Groundwater Remedy Phase 1 Construction, PG&E Topock Compressor Station, Needles, California

### PG&E TOPOCK GROUNDWATER REMEDIATION PROJECT

#### Work Variance Request #5 – Phase 1 Construction of the Remedy Produced Water Conditioning System

PROCESS WATER  
TANK FARM PLAN  
GAS TRANSMISSION & DISTRIBUTION  
PACIFIC GAS AND ELECTRIC COMPANY  
SAN FRANCISCO, CALIFORNIA

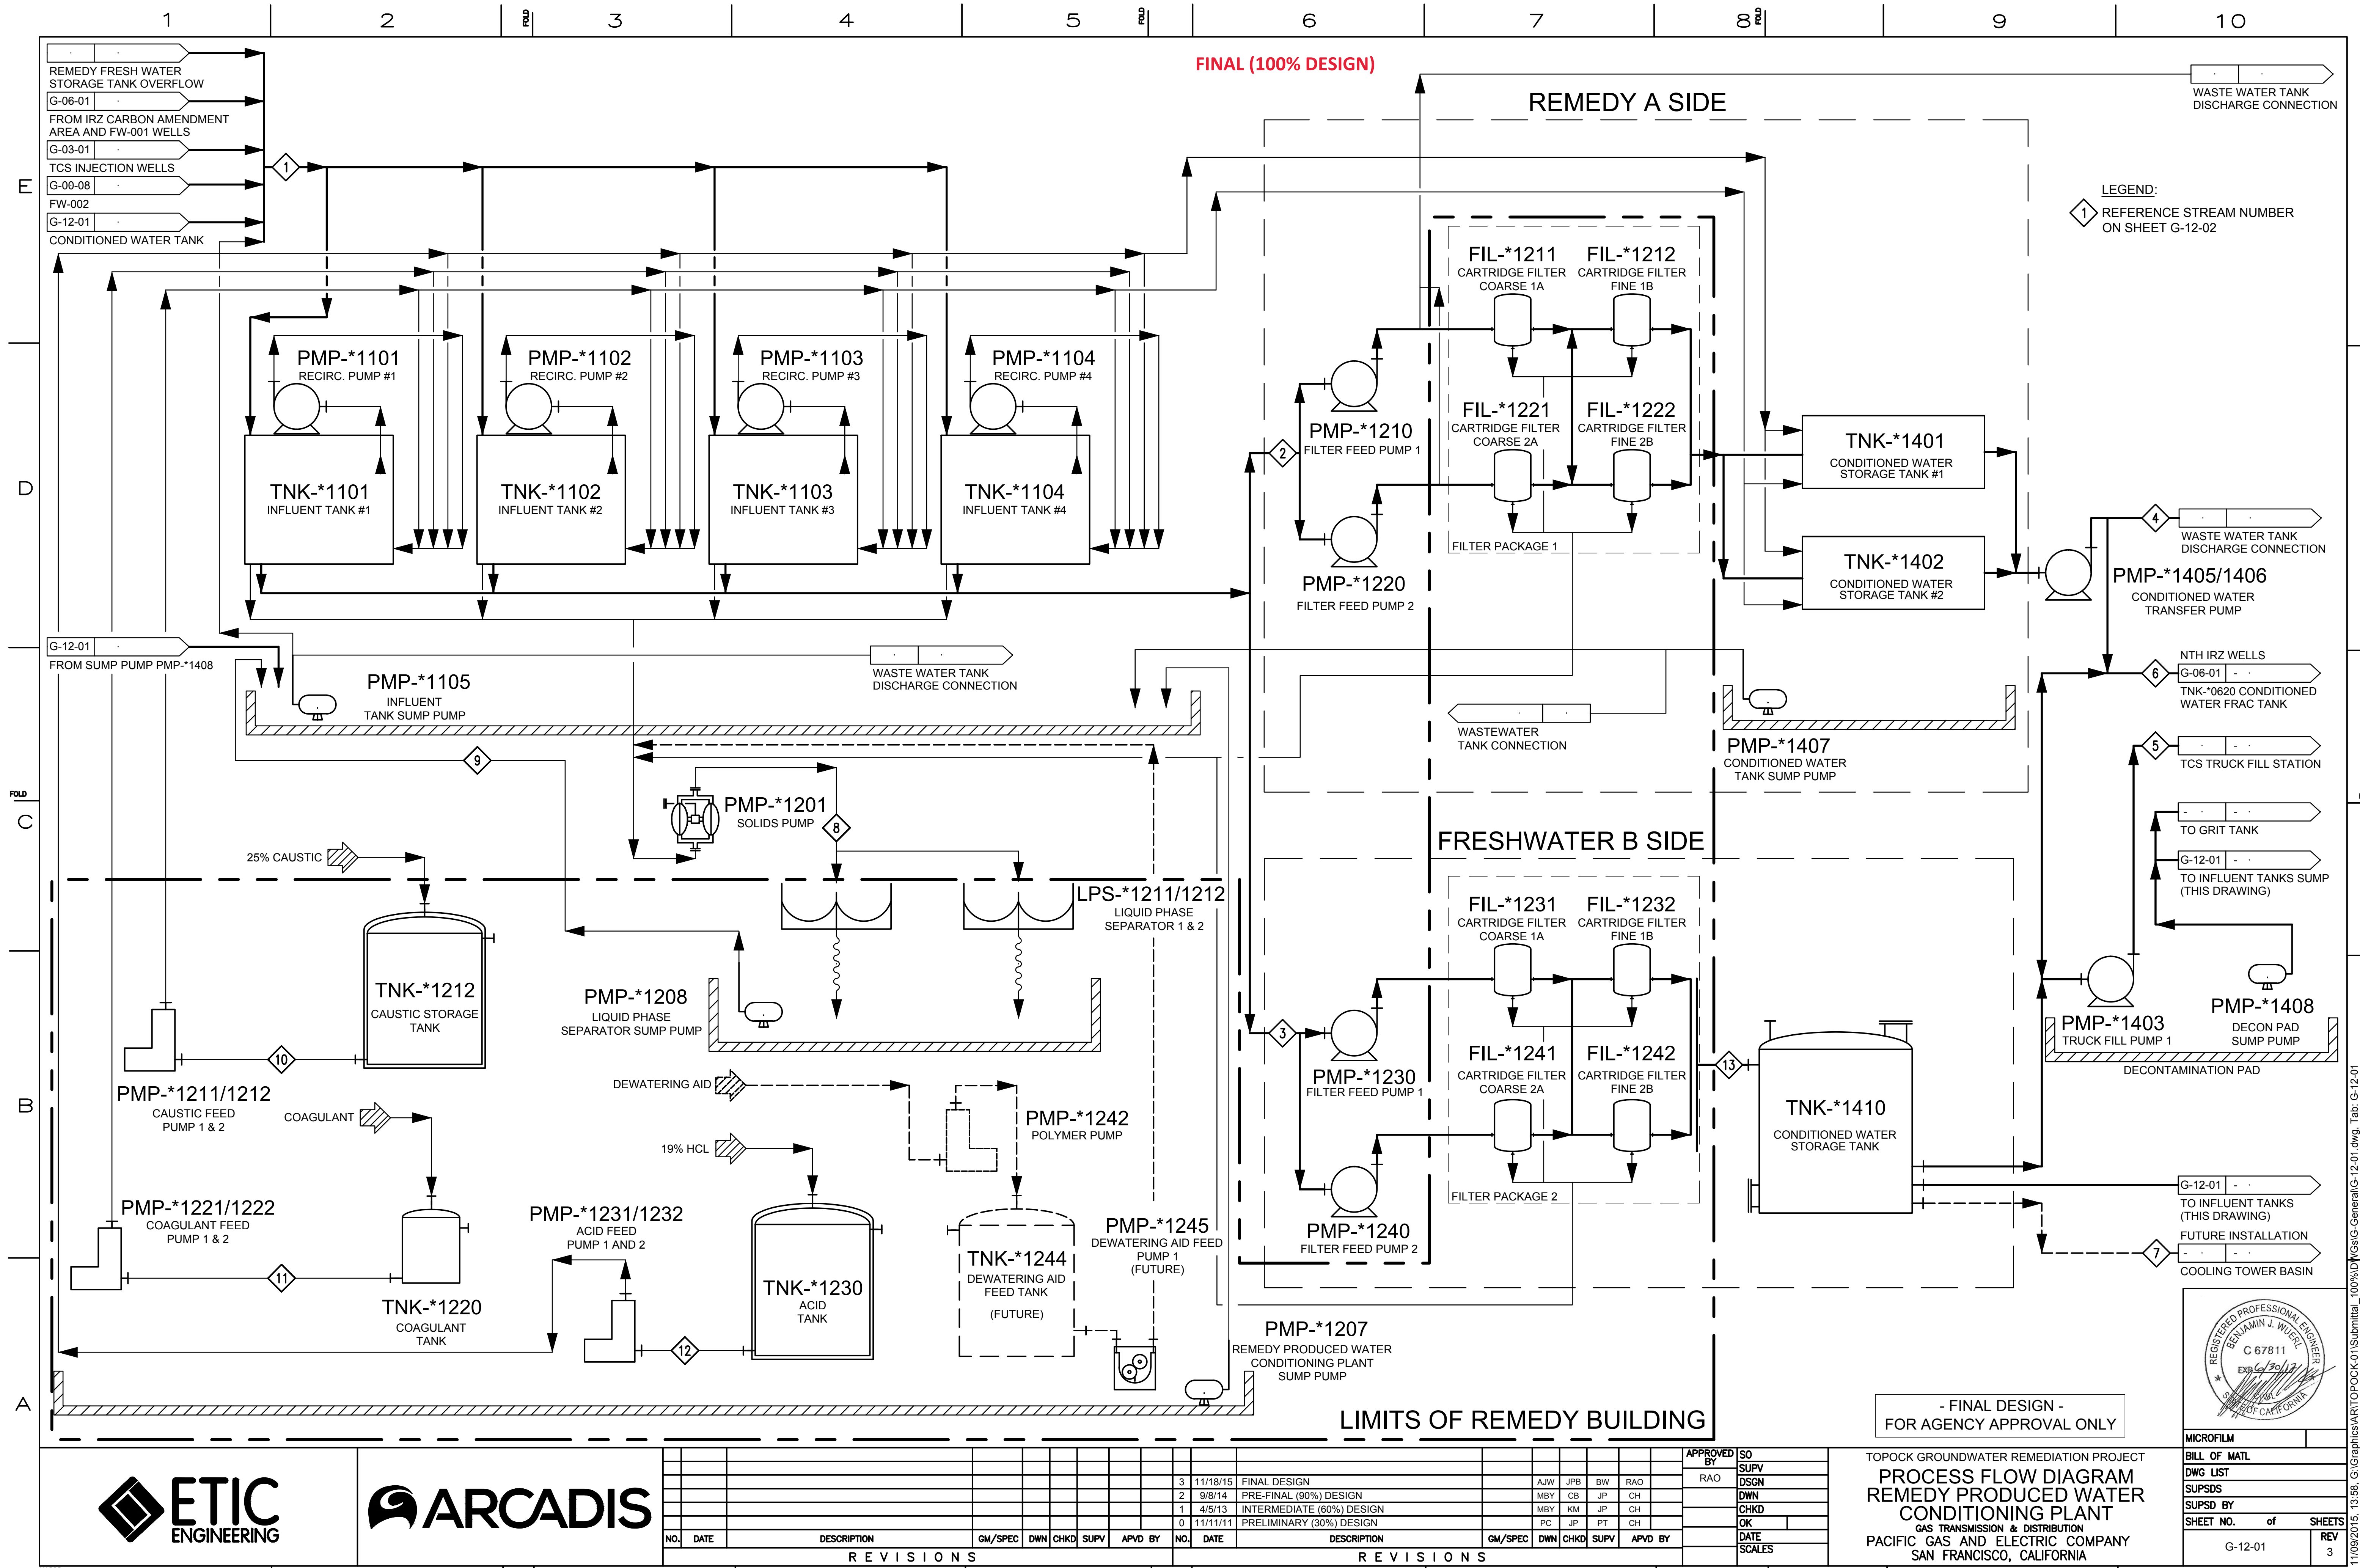
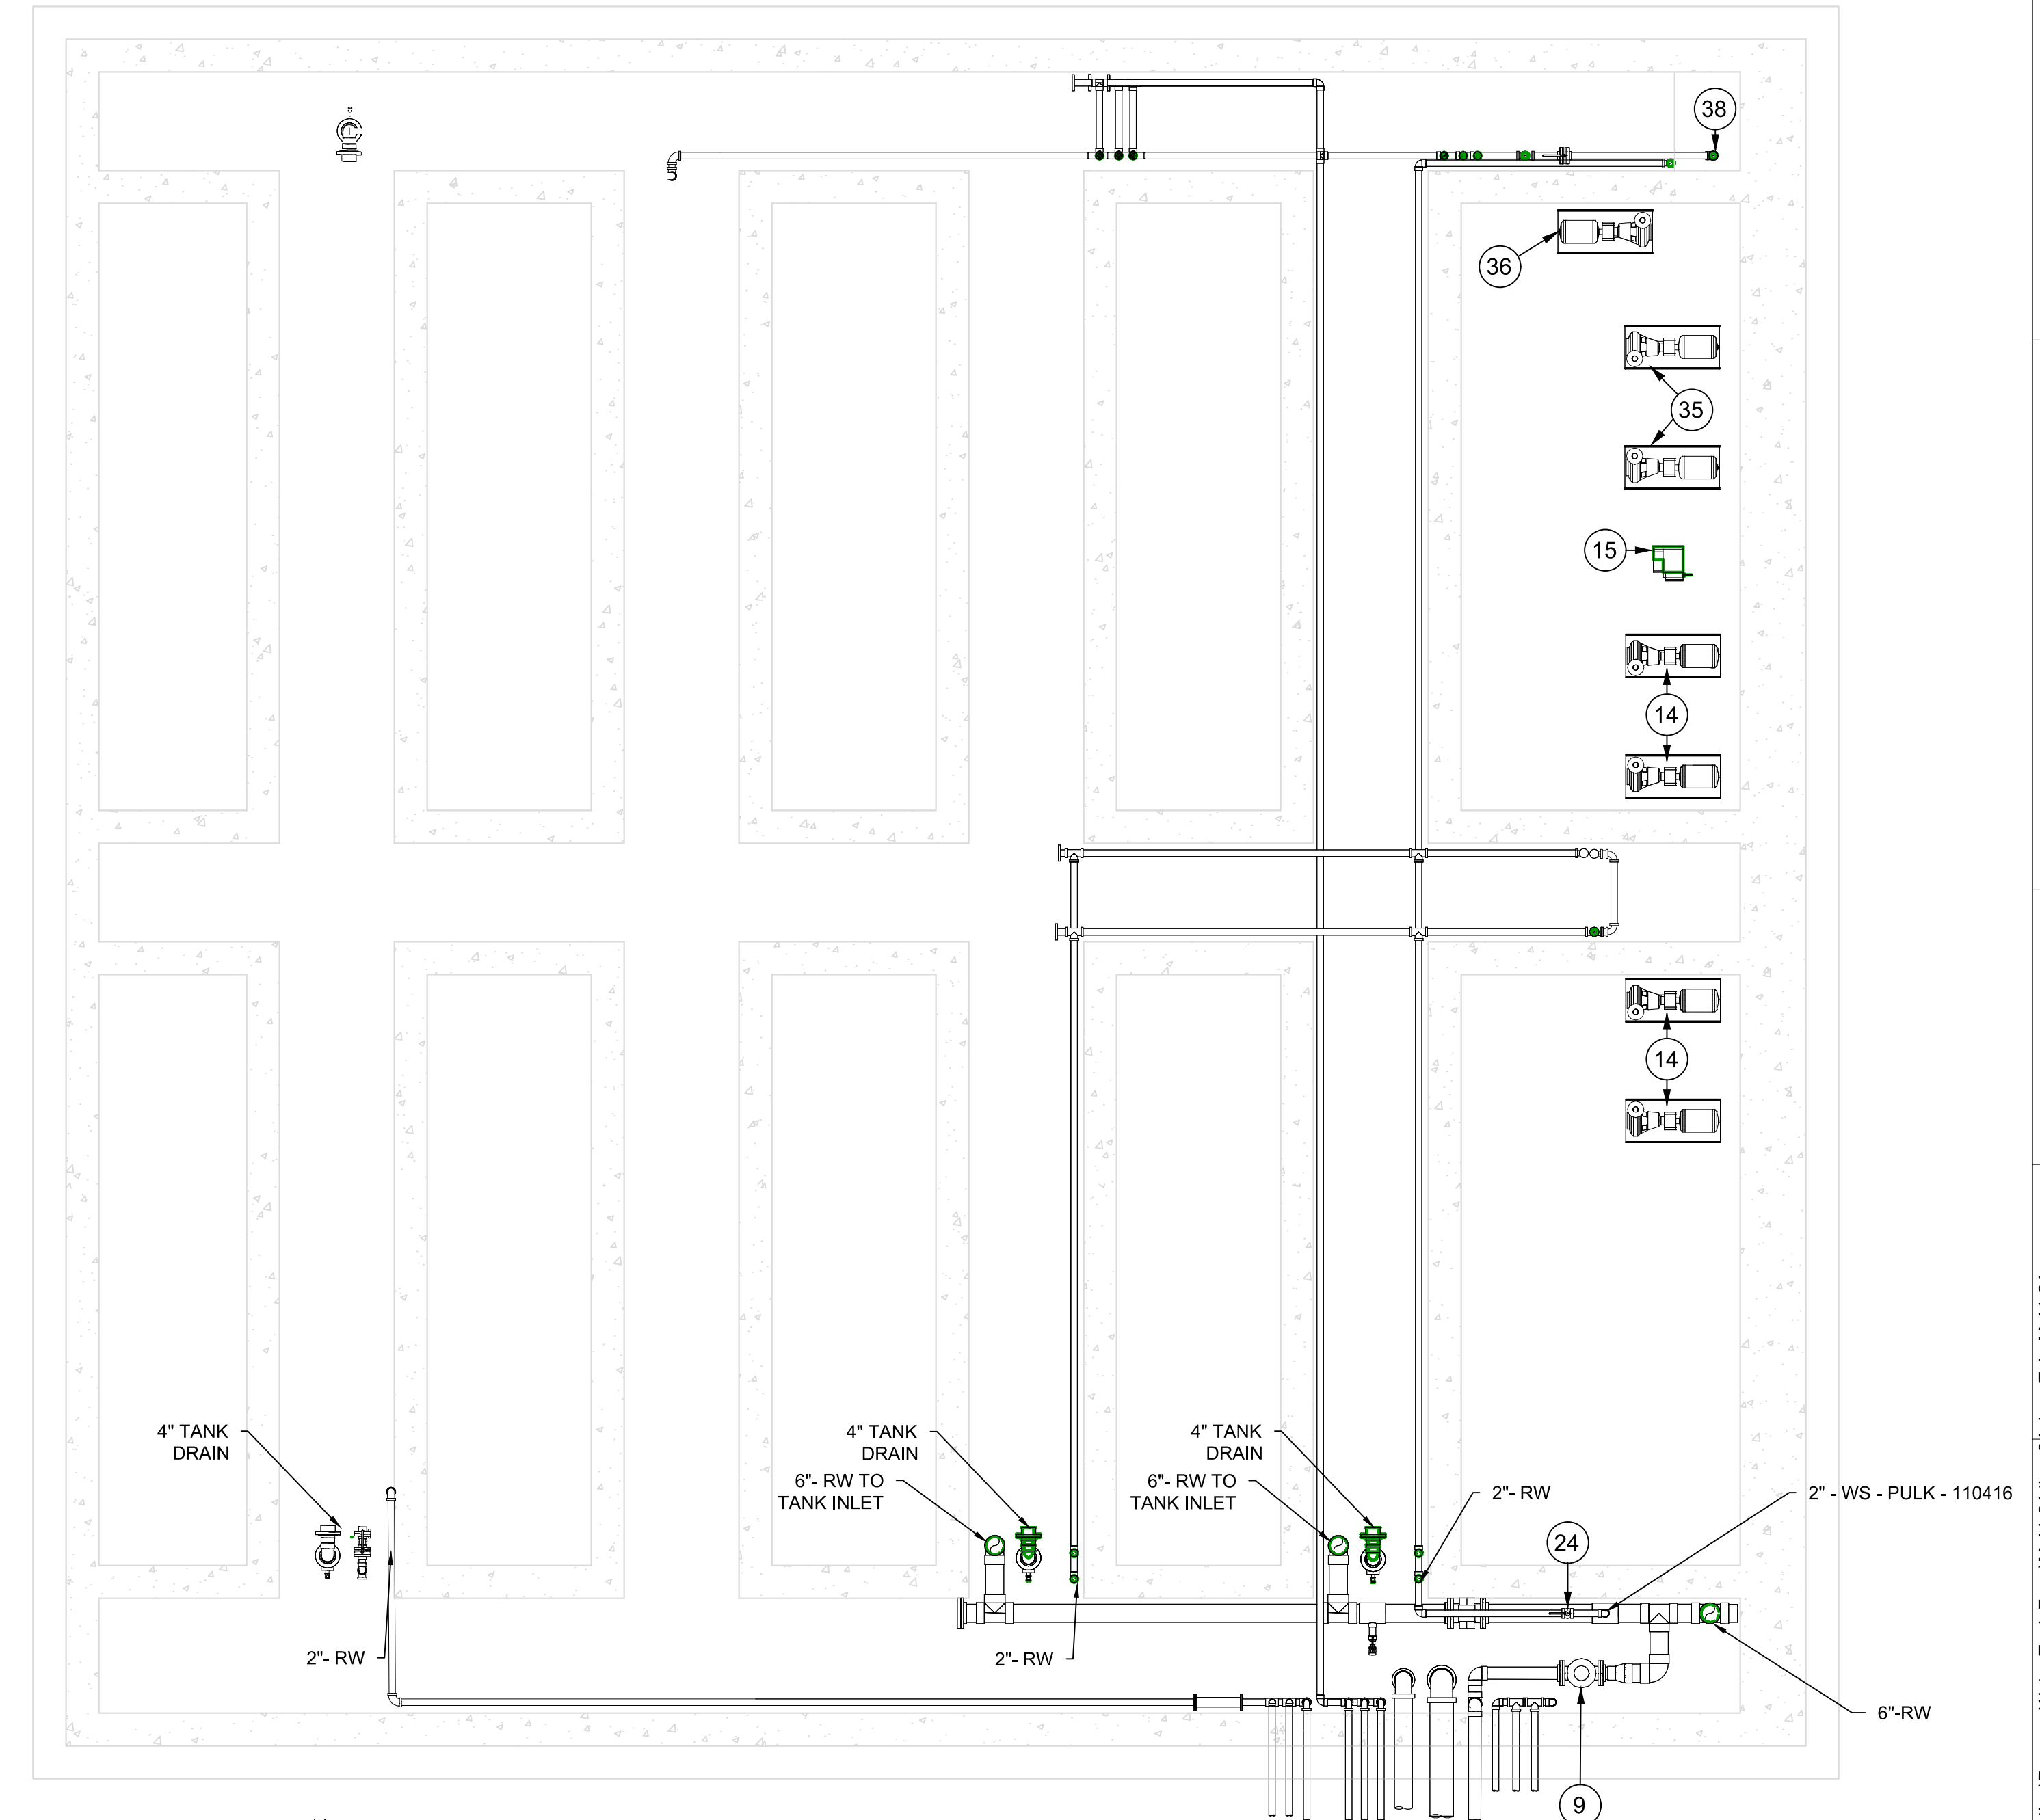
1. **Construct Phase 1 of the RPWC system within the approved footprint of the influent tank farm** – The influent tank farm footprint in the final design has space for four 20,000-gallons frac tanks and associated valves and pumps. In Phase 1, PG&E proposes to install two frac tanks for influent wastewater, one frac tank for conditioned wastewater, two cartridge filters, one phase separator, chemical containers, and associated valves, pumps, piping, and instrumentation within this footprint. To protect the filters, phase separator, and chemical containers, shade fabric may be placed in the tank farm. See Drawing M-11-01.

During Phase 1 construction and for the A-side of the RPWC system, PG&E proposes to install two frac tanks for influent wastewater, one frac tank for conditioned wastewater, two cartridge filters, one phase separator, chemical containers, and associated valves, pumps, piping, and instrumentation within the influent tank farm footprint. With two frac tanks for influent wastewater, there are approximately 10 days of storage capacity at the RPWC Tank Farm for backwash operations when the IRZ is online.
